Re: Minor Project Refinement No. 11 for the South Orange County Reliability Enhancement Project.

South Orange County Reliability Enhancement Project CPUC Minor Project Refinement Form

SOCRE PROJECT
MPR-11 FIGURE 1
SAN JUAN CAPISTRANO SUBSTATION
 San Juan Capistrano
 Orange County, CA

View of MPR-11 Calle Lorenzo work area, facing north from the corner of Calle Lorenzo and Camino Capistrano, facing N.

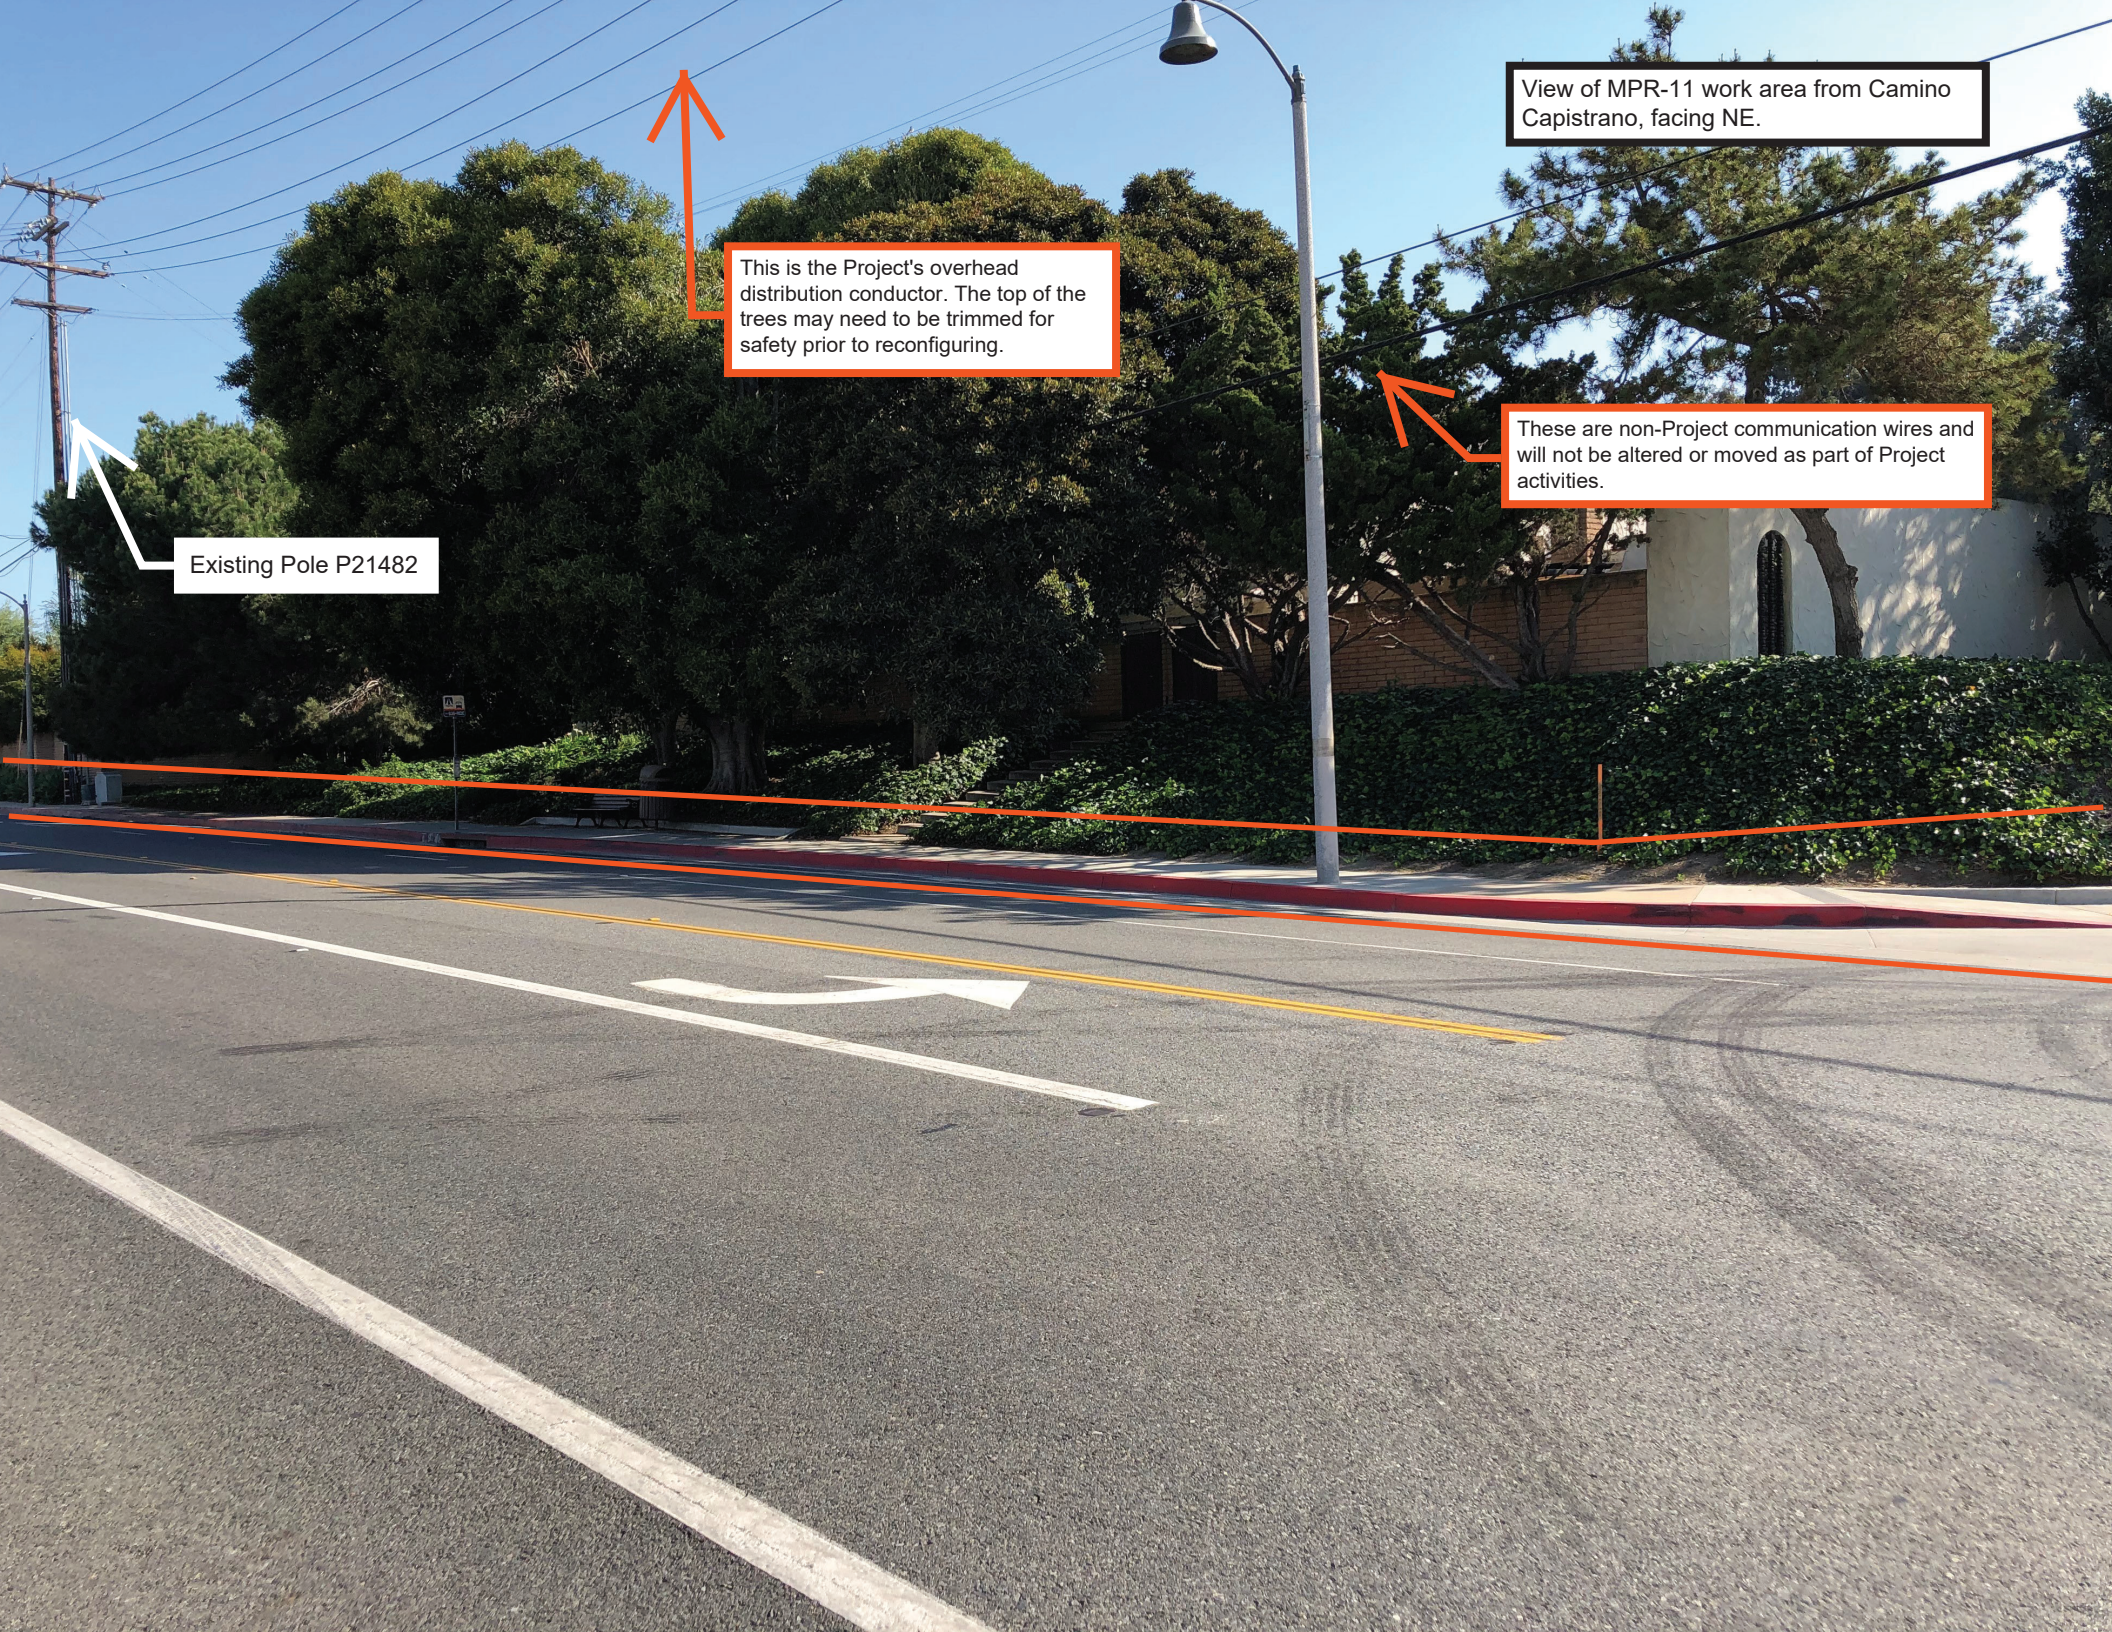
<input type="checkbox"/> N	<p>Capistrano. There is one ornamental shrub (<i>Acacia cyclops</i>) that may need to be removed in the Calle Lorenzo work area (Attachment C: MPR-11 Site Photographs). Tree trimming would be required along the tops of the trees on Camino Capistrano to allow a minimum of 4 feet of clearance. Trimming would be limited to the extent practicable to meet General Order (GO) 95 standards. It is not anticipated that limbs on the west side of the trees facing Camino Capistrano would need to be removed. Although Camino Capistrano is a designated scenic corridor, the effects of trimming will be temporary in nature and would not significantly diminish the appearance of the mature line of trees or introduce a new source of visual contrast. Therefore, these minor changes will not create a new significant impact to visual resources or create an increase in severity to previously identified impacts with implementation of the below APMs and MMs.</p> <p>The transmission pole replacement work on Avenida de la Vista would also not result in a new significant visual impact as there would be minimal increase in visual contrast because there are already existing utility infrastructure elements in this location, including the existing wood pole to be replaced and the adjacent steel transmission cable pole (Z122016). The new steel transmission pole Z225613 will be 79 feet tall, which is approximately 12 feet taller than the existing wood transmission pole. The increase in height is due to a change in the conductor configuration to better match the existing and new configurations. The relocation of the pole will also move it out of the sidewalk.</p> <p>The neighborhood near the pole replacement location was not identified as an area with high viewer sensitivity in the FEIR. For these reasons, MPR-11 activities would not result in a substantial increase in severity or a new significant impact from those analyzed and disclosed within the Project's FEIR, Section 4.1.</p> <p>The Calle Lorenzo work area would be restored to pre-Project conditions as required upon completion of Project activities. No new or altered APMs or MMs would be required, and the following APMs and MMs would be implemented for MPR-11 work activities:</p> <ul style="list-style-type: none">• APM AES-1: Clean Work Areas• APM AES-2: Restoring Disturbed Areas• MM AES-2: Minimize Clearing and Ground Disturbance and Restore Disturbed Area to Pre-Project Conditions• MM AES-4: Glare and Color Contrast Reduction for Transmission Structures and Conductors

View of MPR-11 work area on corner of Calle Lorenzo and Camino Capistrano (shown in orange), adjacent to NTP-4 work area (shown in red). Approximate locations of the fuse box and underground conduit location shown in blue, facing S.

Acacia cyclops

COA-5. No tree removal will occur as part of MPR-11 activities. Trimming of trees along the east side of Camino Capistrano north of Calle Lorenzo (shown in photo #3 in Attachment C, MPR-11 Site Photographs), if determined necessary to meet General Order (GO) 95 standards, will be limited to the tops of the trees to allow a minimum of 4 feet of clearance for the new overhead conductor. Trimming will be the minimum necessary to meet General Order (GO) 95 standards. Limbs on the west side of the trees facing Camino Capistrano will not be removed without obtaining approval from the CPUC prior to trimming.
